MEMORANDUM

To: Development Review Board
From: Mary O'Neil, AICP, Senior Planner
Date: December 2, 2014
RE: 247-249 Pearl Street

File: ZP14--0884CA/MA

Request: Amendment to site and grading plans to allow for residential development and preparation of a Corrective Action Plan (CAP) that avoids removal and disposal of 7,660 tons (approximate grade cut of 7') of contaminated soil. Extend retaining wall around site.

GRADING, DRAINAGE & UTILITY PLAN

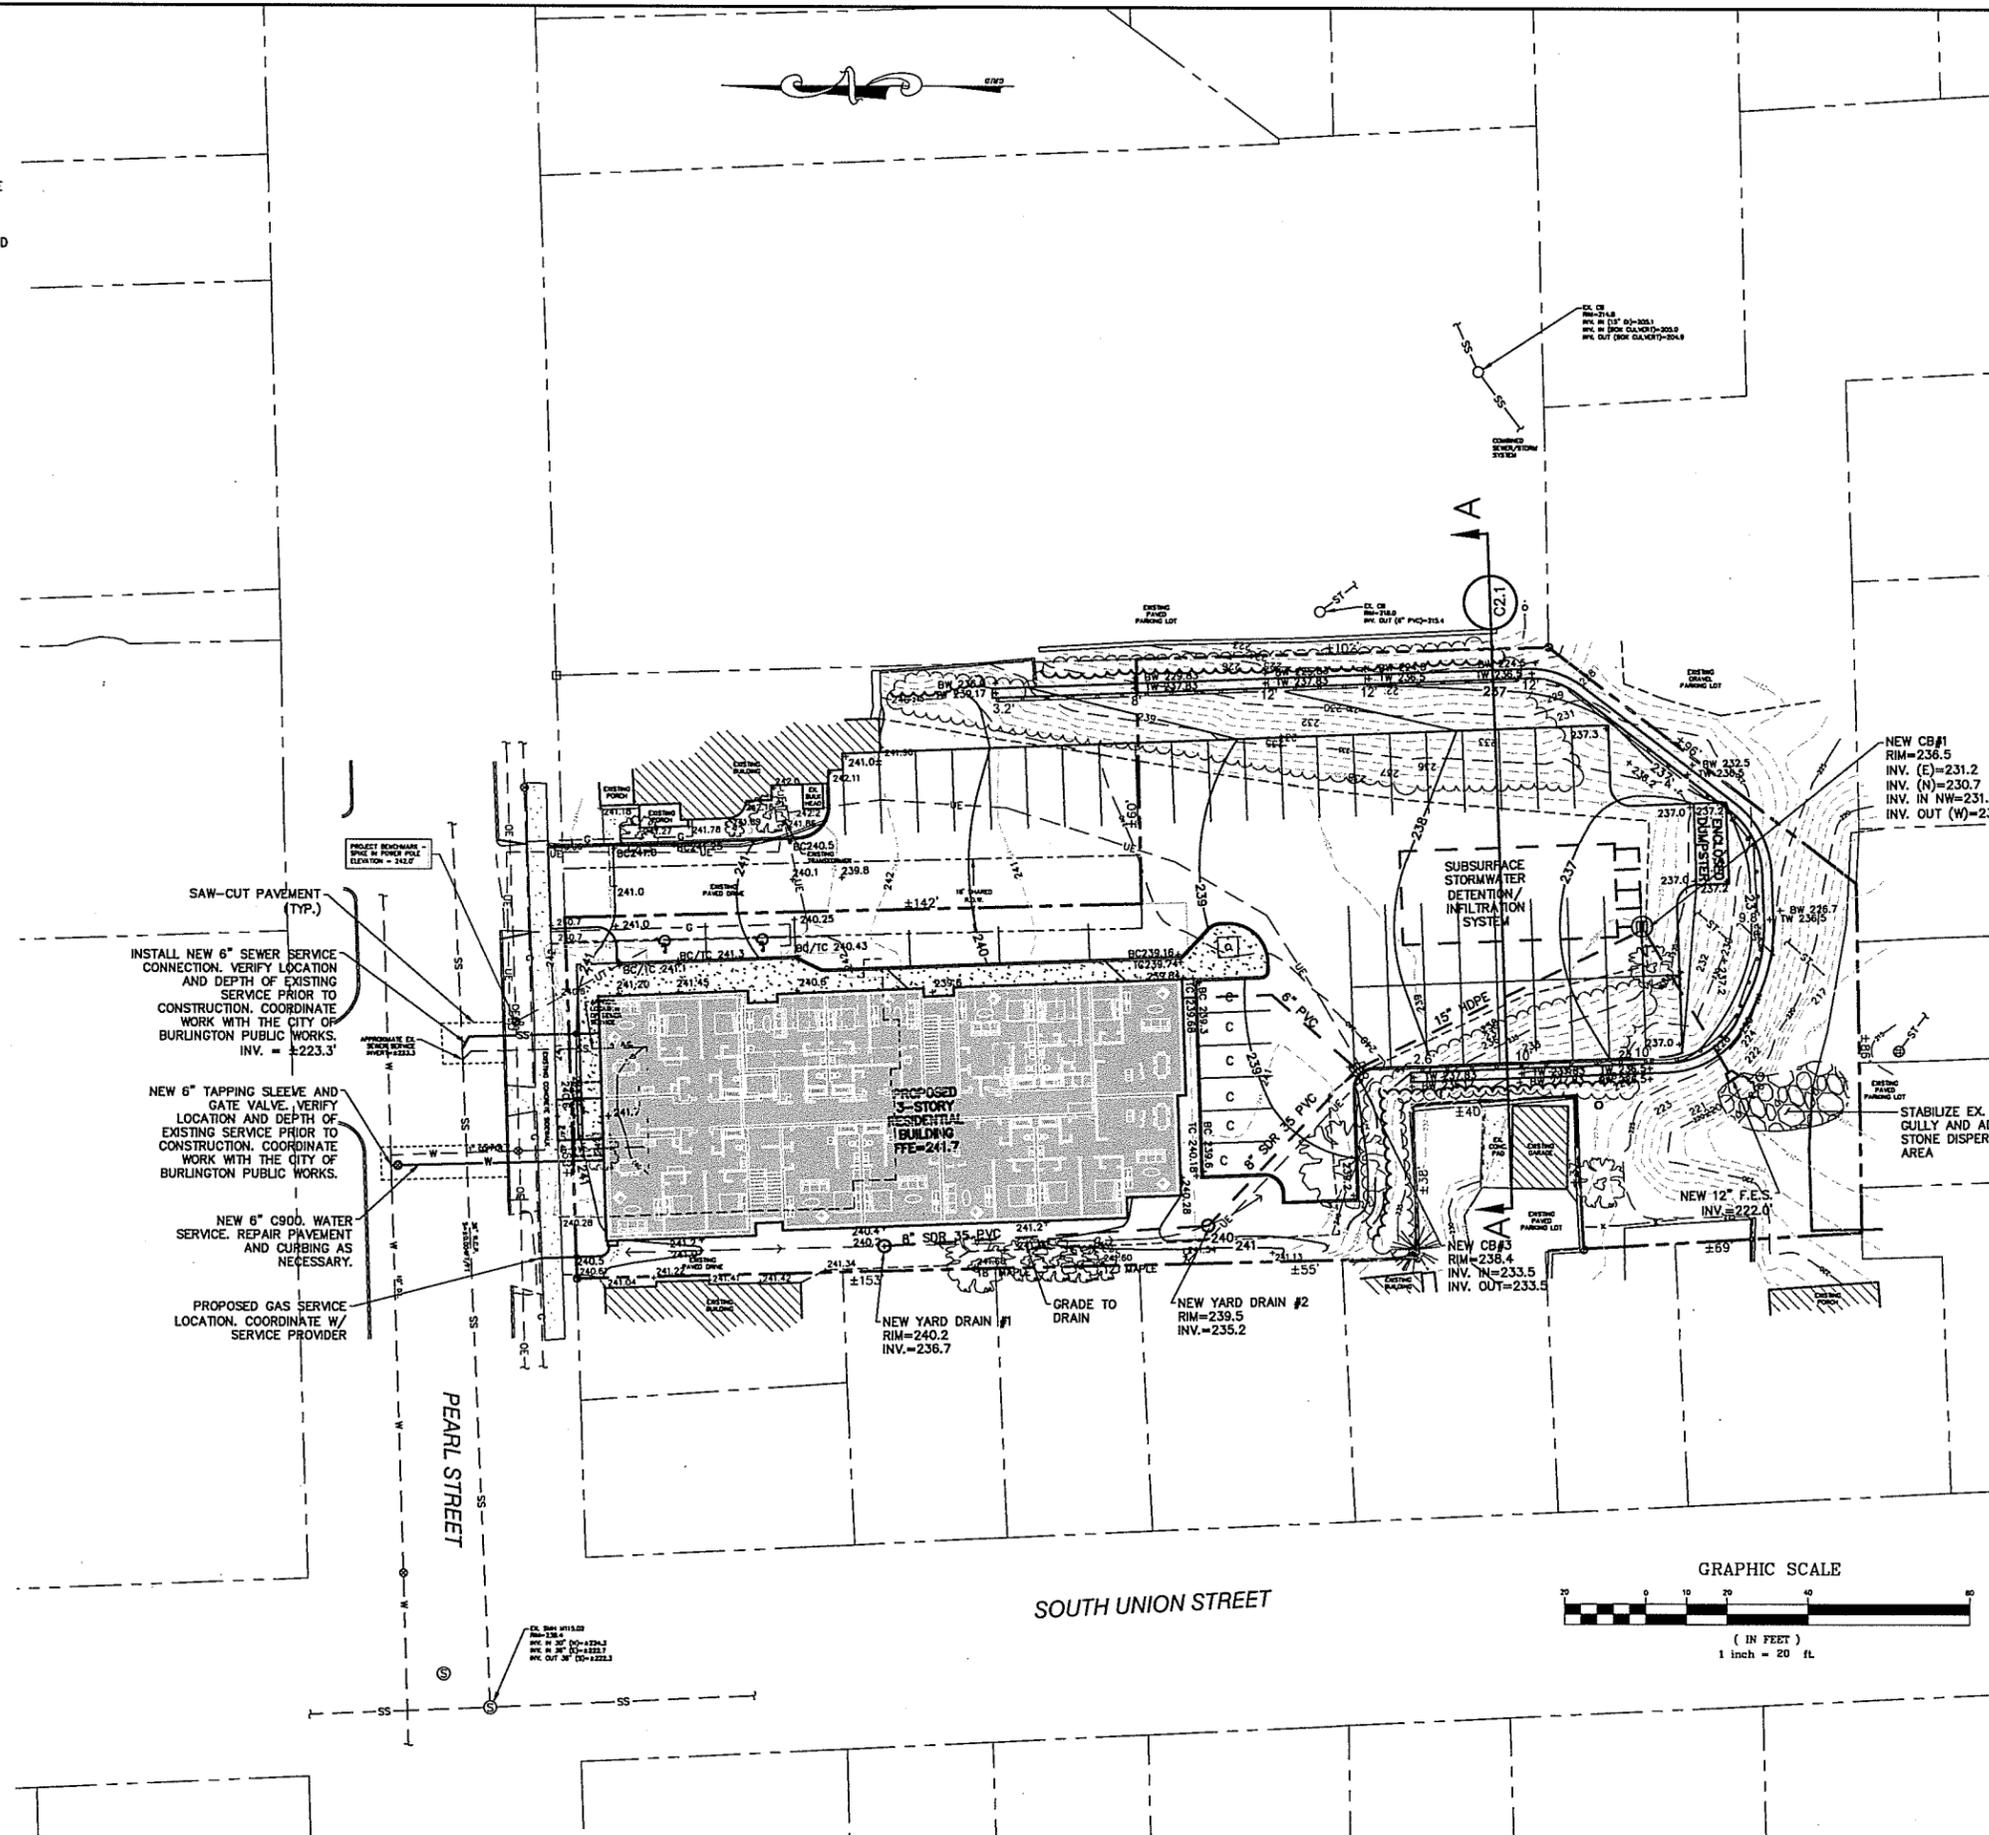
Grading changes will require installation of a continuous retaining wall from the east, to the south, to the west; creating somewhat of a basin. The wall will be required to meet the approval of the city engineer per this standard. The applicant had previously suggested a “redi-rock” product may be utilized, with railings around the taller sections. Confirmation will be required. The height of the wall at any given location has been annotated (see above image) and ranges in height from 2.6’ on the west to 12’ in height along the east where there has existed some heavy scrub growth; however the likelihood of site development may require the wall construction nonetheless.

The site grading and drainage plan must be approved by the City Stormwater Administrator.

RETAINING WALL DETAIL

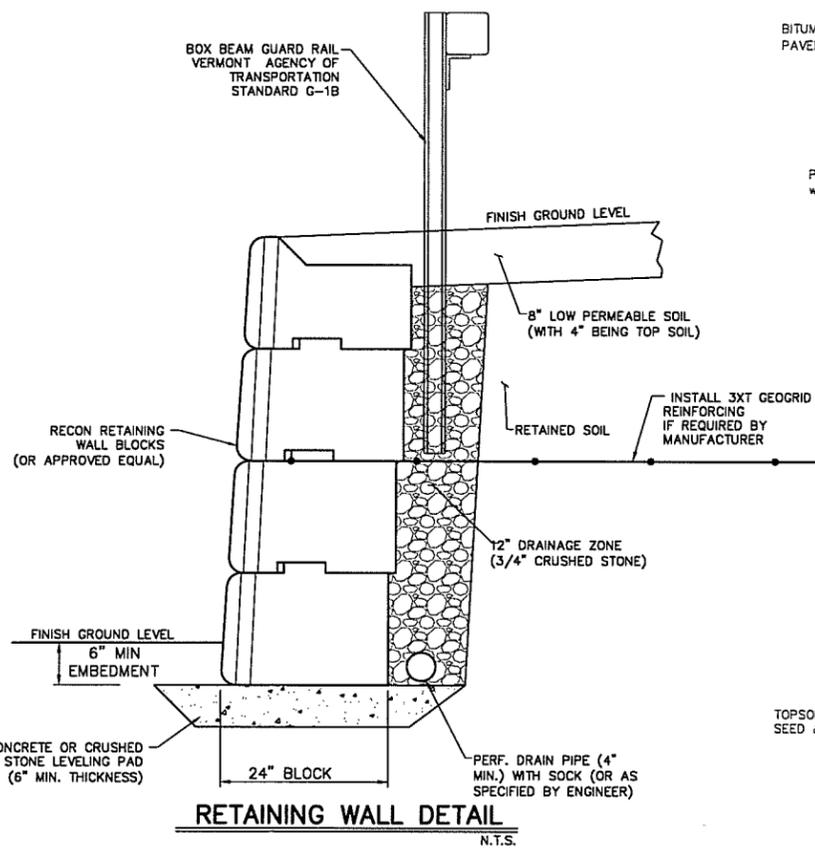
A site section has been provided to understand the proposed terrain, retaining wall and parking barriers. Quite simply, redevelopment of the site with removal of contaminated fill will prove to be too costly. This amendment asks to revise the site grading and drainage plans to allow for redevelopment in a prudent yet economically practical manner. That plan includes more extensive retaining walls, which must be approved by the city engineer for acceptability.
